**Genstar Development Company**
*Winnipeg Region*
*1371 Kenaston Boulevard*
*Winnipeg, Manitoba R3P 2T5*
*Tel: (204) 488-6537*
*Fax: (204) 489-6918*
*Website: www.genstar.com*

**RE: Subdivision and Rezoning & Secondary Plan Amendment – Gunn Redonda [File No. DASZ 18/2014]**

## Land Use Concept

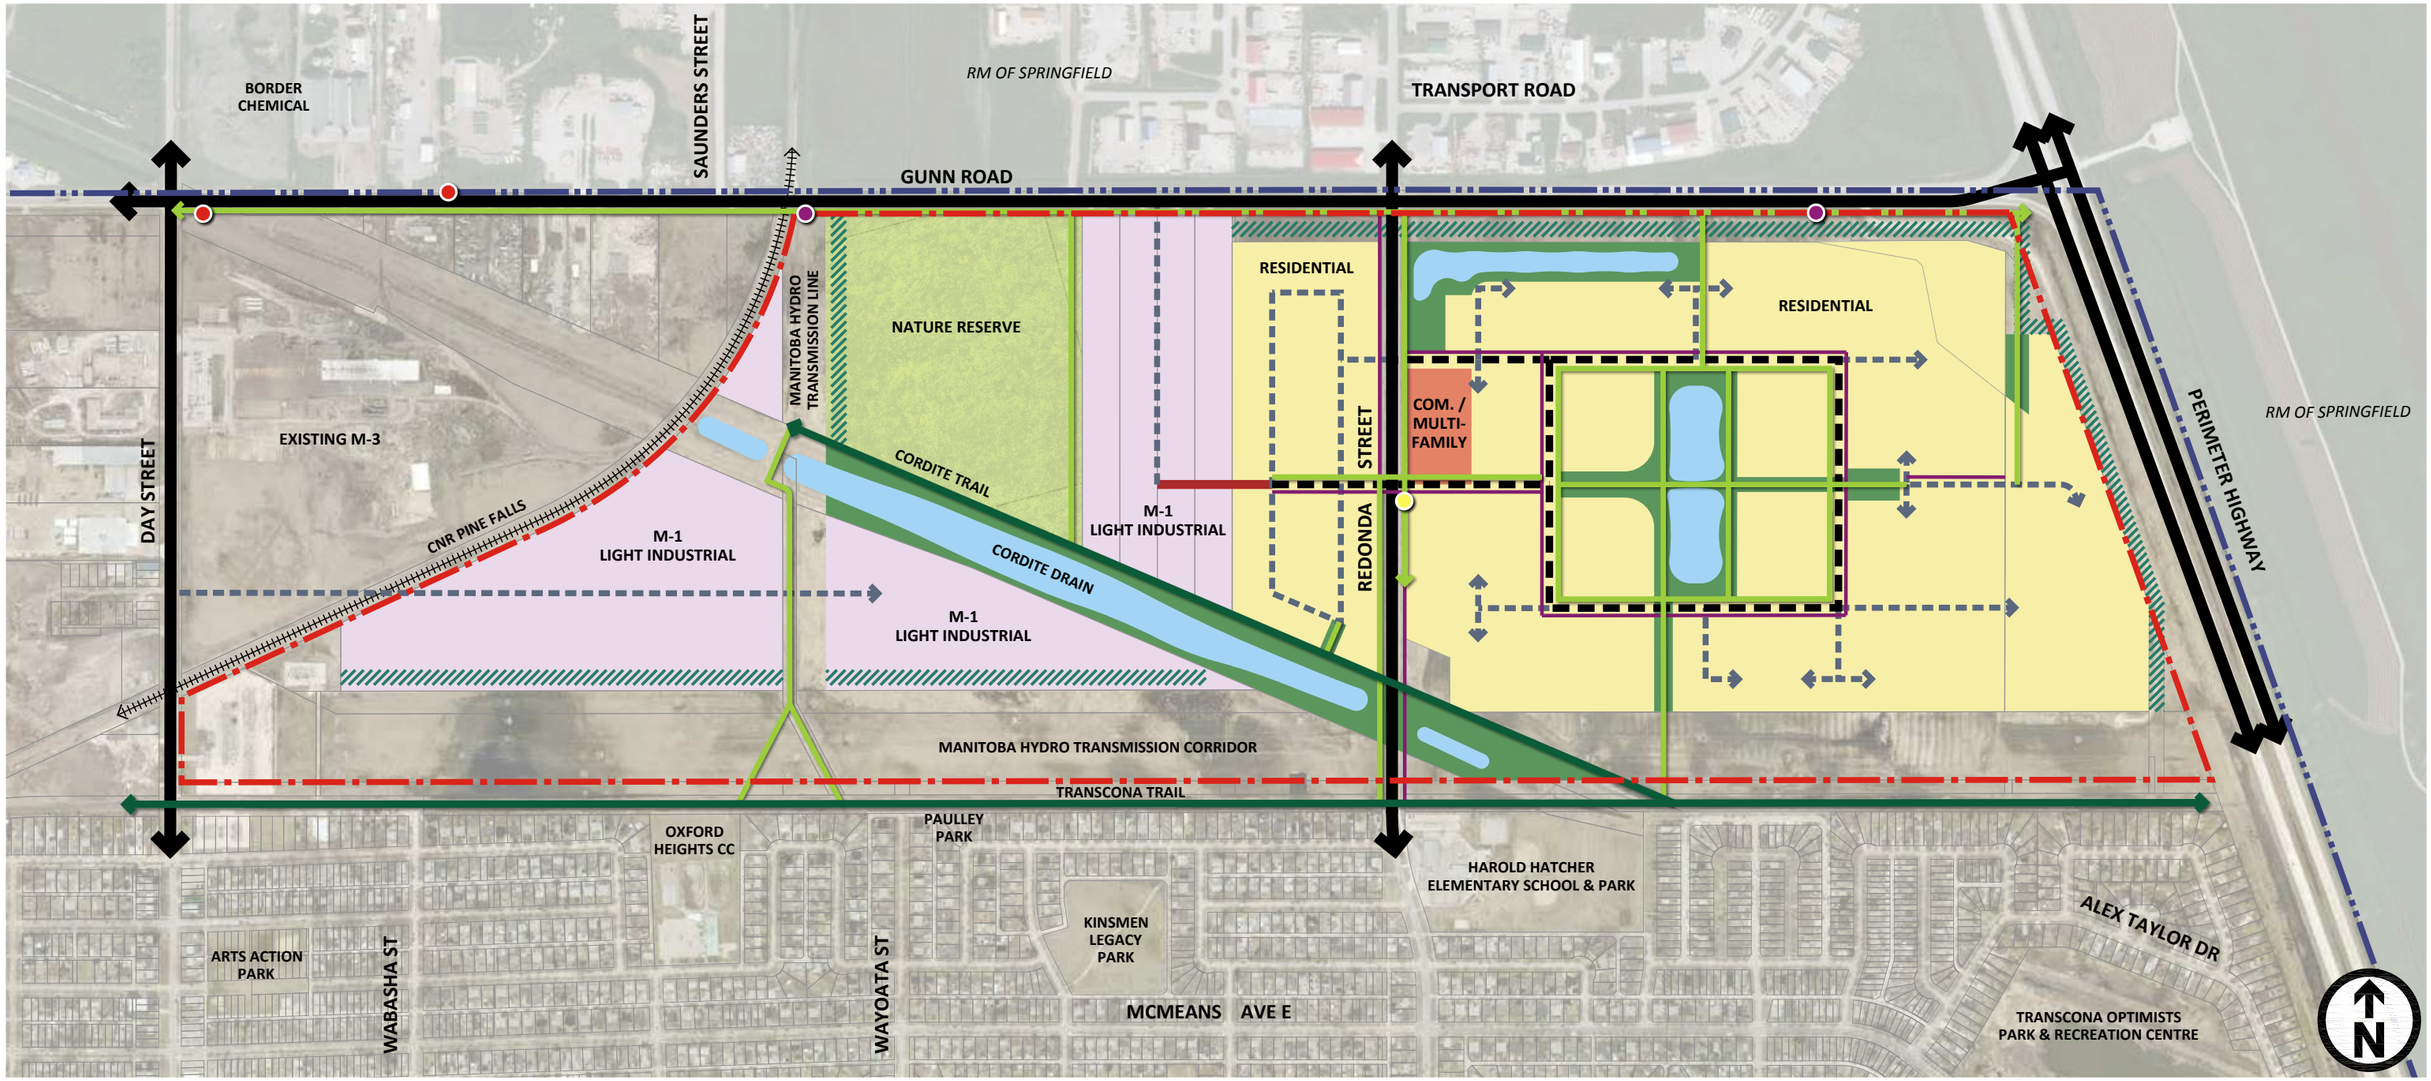
- Figure 3: Land Use Concept (p.12)
- Figure 4: Parks and Open Space System (p.18)
- Figure 6a: Chief Peguis Trail Expressway Sign (p.29)
- Figure 6b: North Woods Development Sign (p.30)
- Figure 7: Road Network Map (p.34)
- Figure 8: Pedestrian and Cycling Network (p.39)
- Figure 9: Municipal Trunk Services Map (p.43)

- Figures 3, 4, 7, and 8 will be consolidated into one Figure, Figure 3.
- Figures 6a and 6b will be removed.

- Figure 4: Gunn Road Buffer
    - Figure 5: Municipal Trunk Services
- Change all references to Figures 4, 7, and 8 to reference Figure 3.
- Change all references to Figure 5 to Figure 4.

Municipal Trunk Services

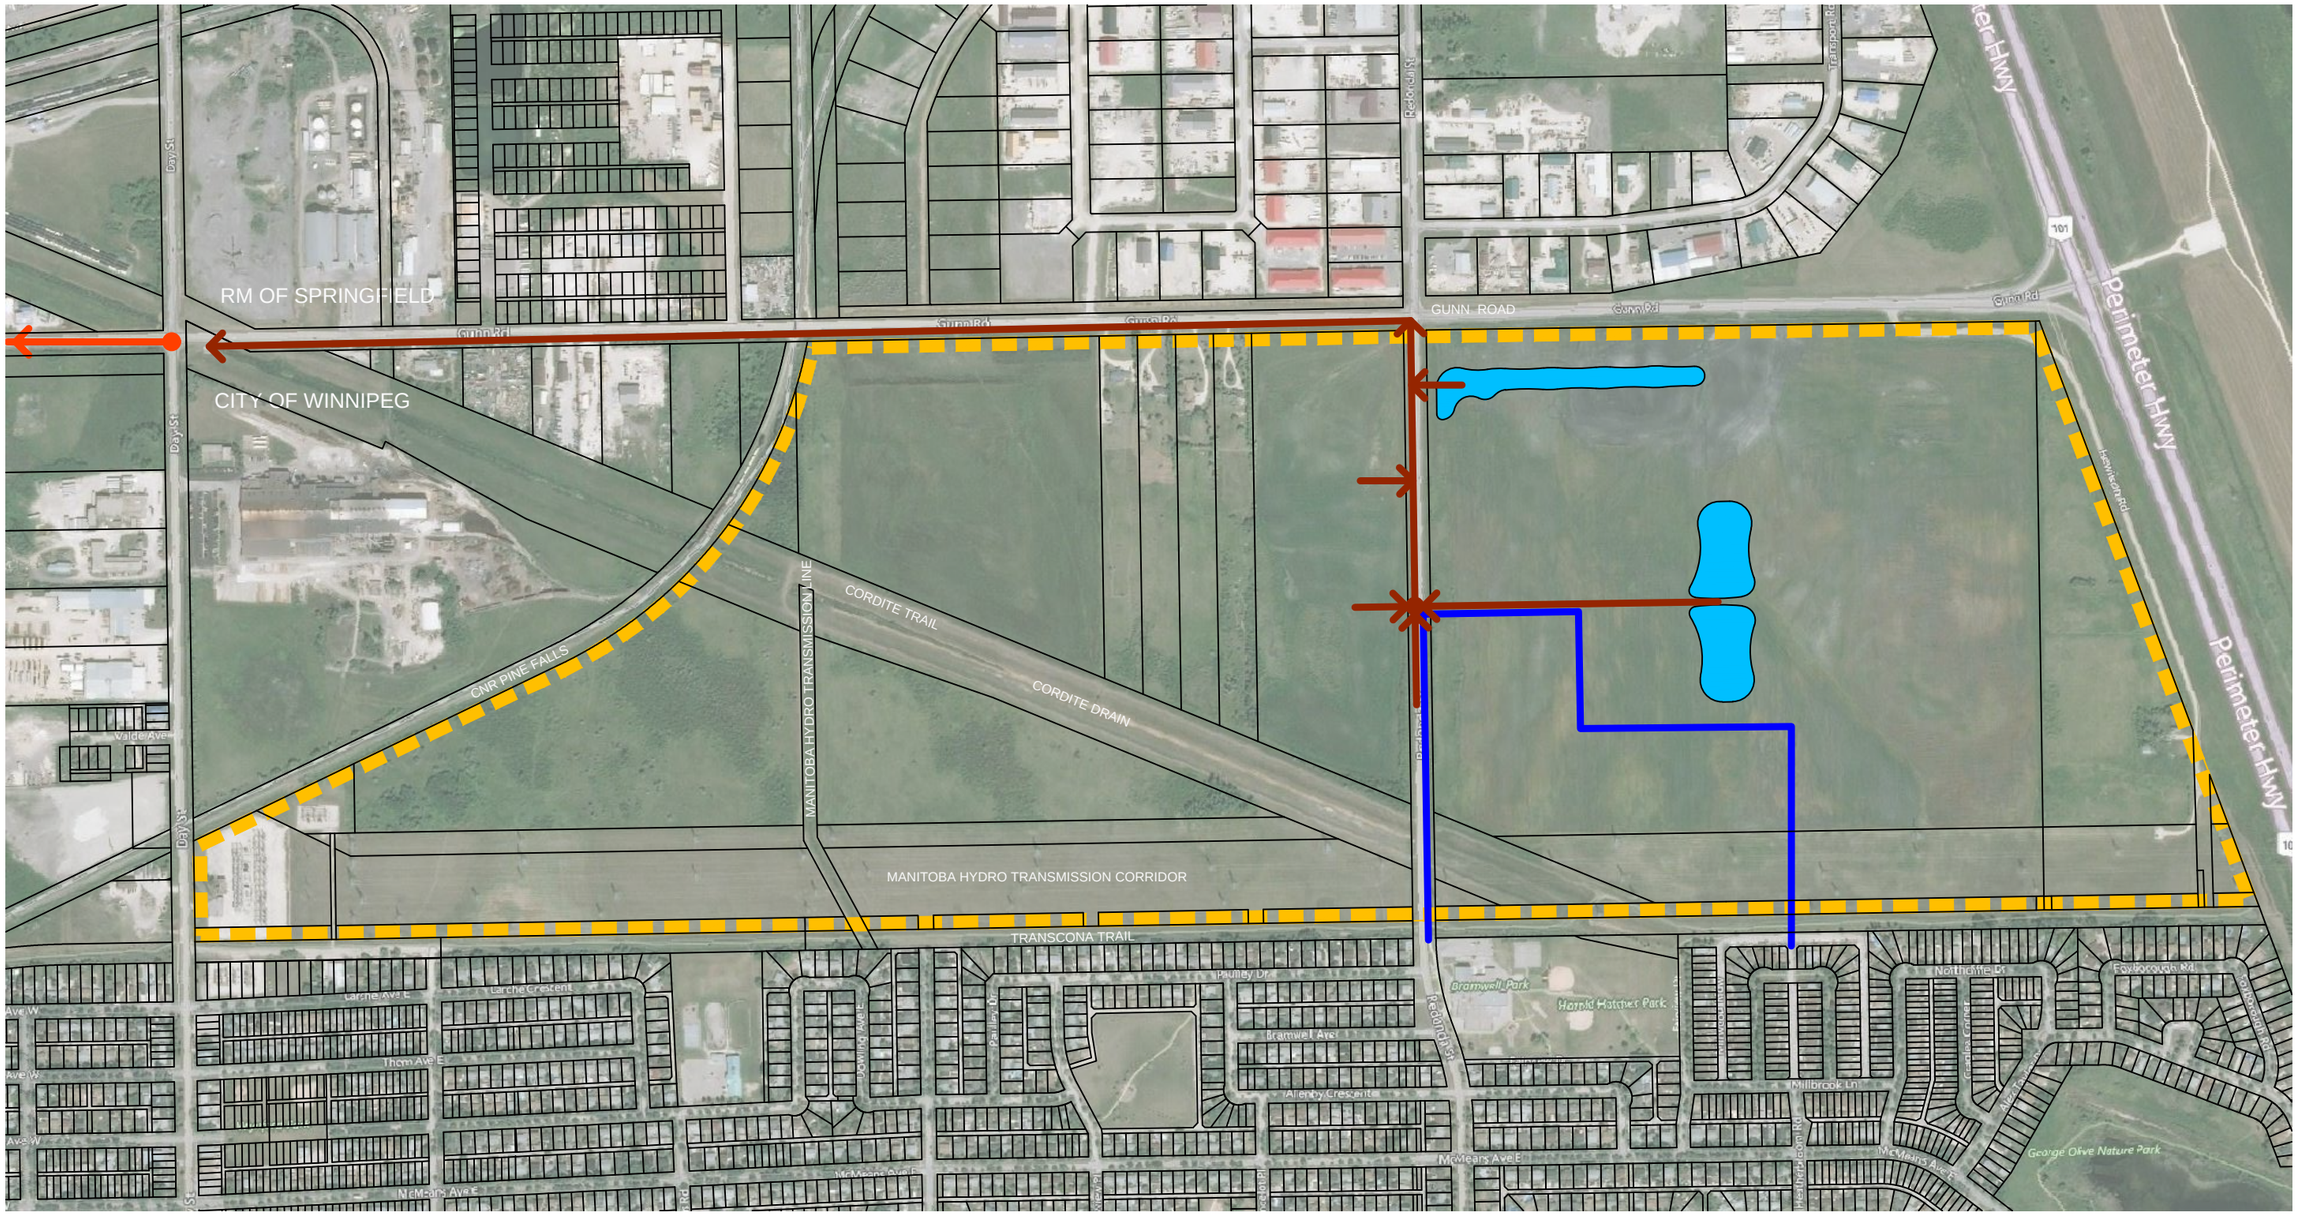
- Figure 9 will be revised to align with the proposed redesign.

- Change all references to Figure 9 to Figure 5.
- P.7 - Edit Property Ownership Figure to change North Grassie Properties Lands to Private Landowner 1 (or 8) and change remaining Private Landowner references accordingly.
